Illinois Department of Transportation

SUBJECT: FAU Route 8419 (IL Route 140)
Project M-TE-00D7(021)
Section 99-00048-01-PV (Vandalia)
Fayette County
Contract No. 95500
Item 007 (Addendum A)
September 21, 2007 Letting

To clarify information it is necessary to revise the following:

Boring Location
Diagram

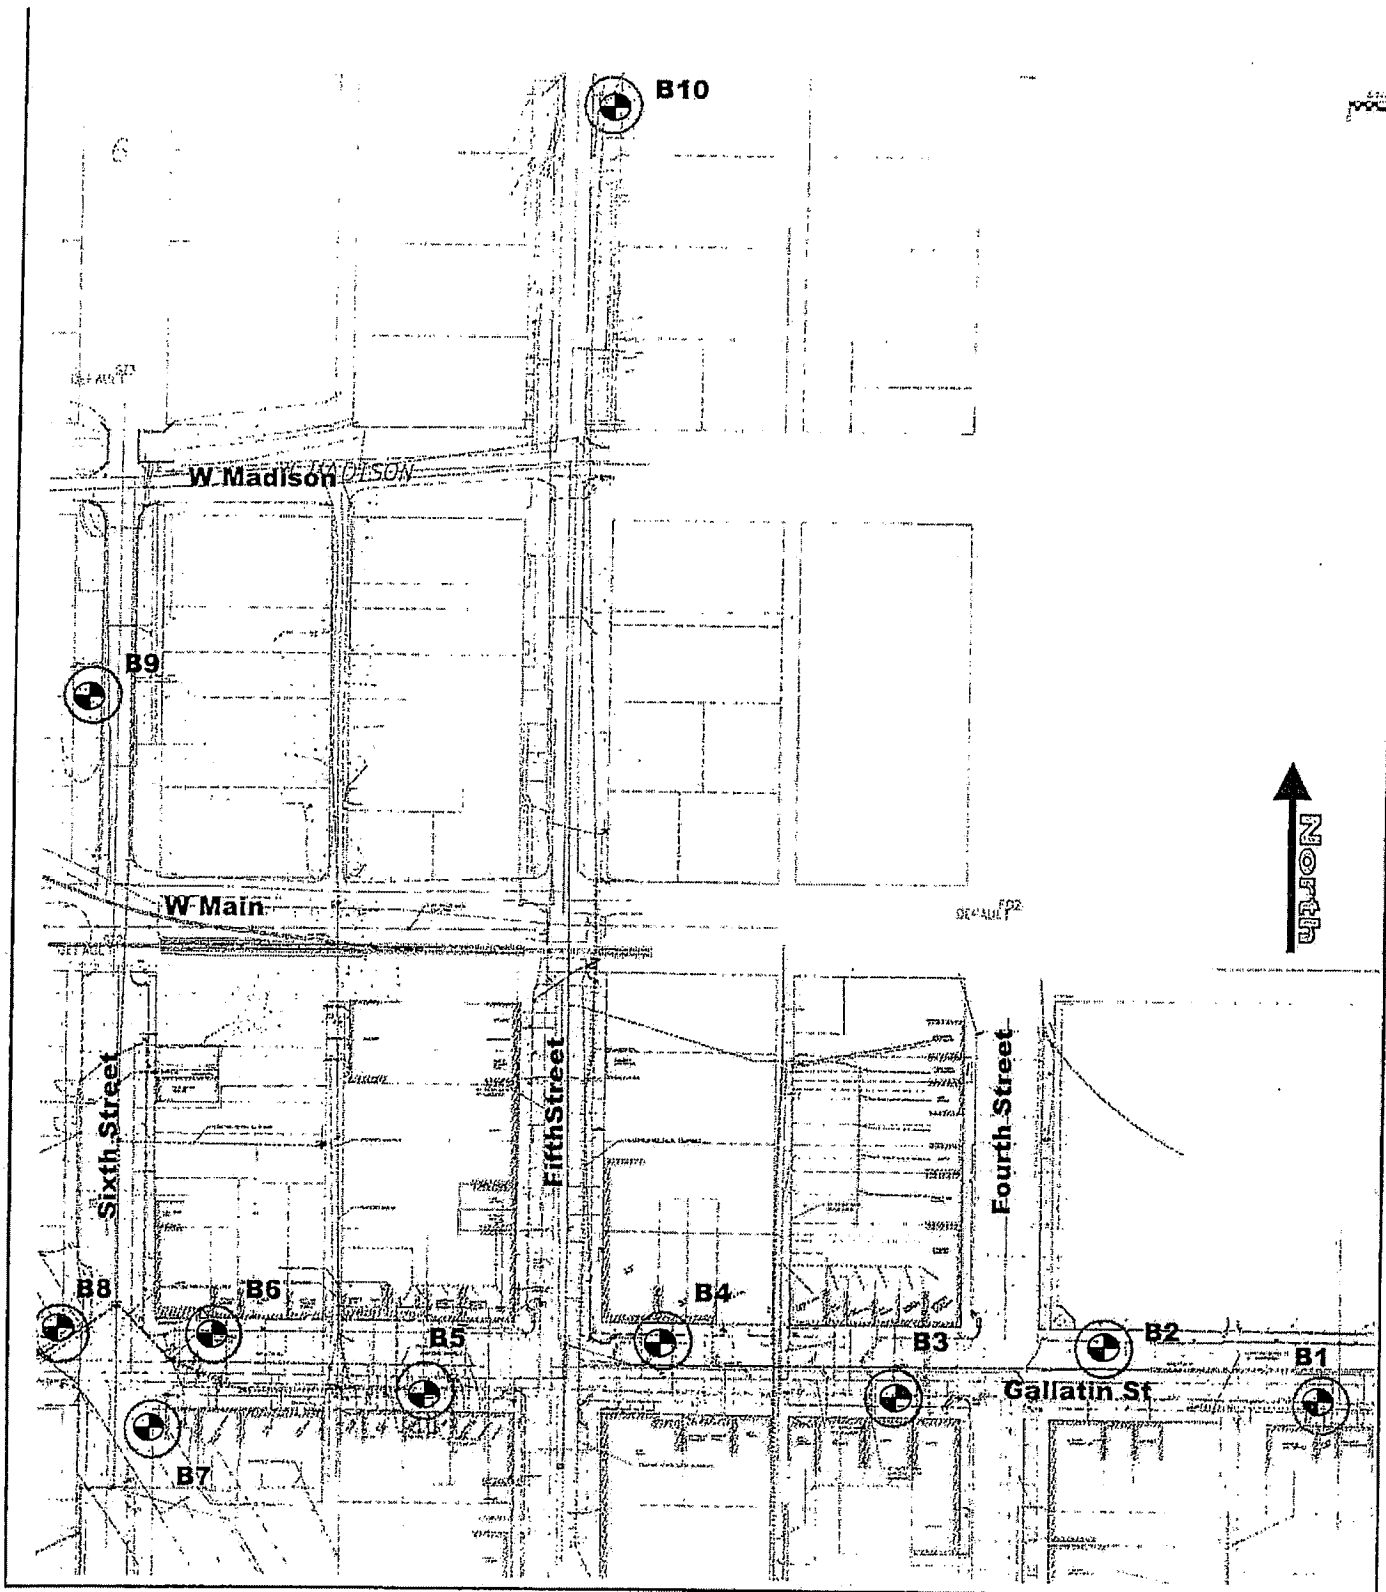
On July 26 and 27, 2007, we drilled ten soil borings along Gallatin, Sixth, and Fifth Streets, in locations as indicated on the enclosed Boring Location Diagram.

The above boring locations and depths are indicative of excavations that will probably require dewatering or sheet piling for installation of the sewer line. Without dewatering the excavation, or using sheet piles, the sand will flow and become "quick", resulting in loss of stability of the bottom of the excavation.
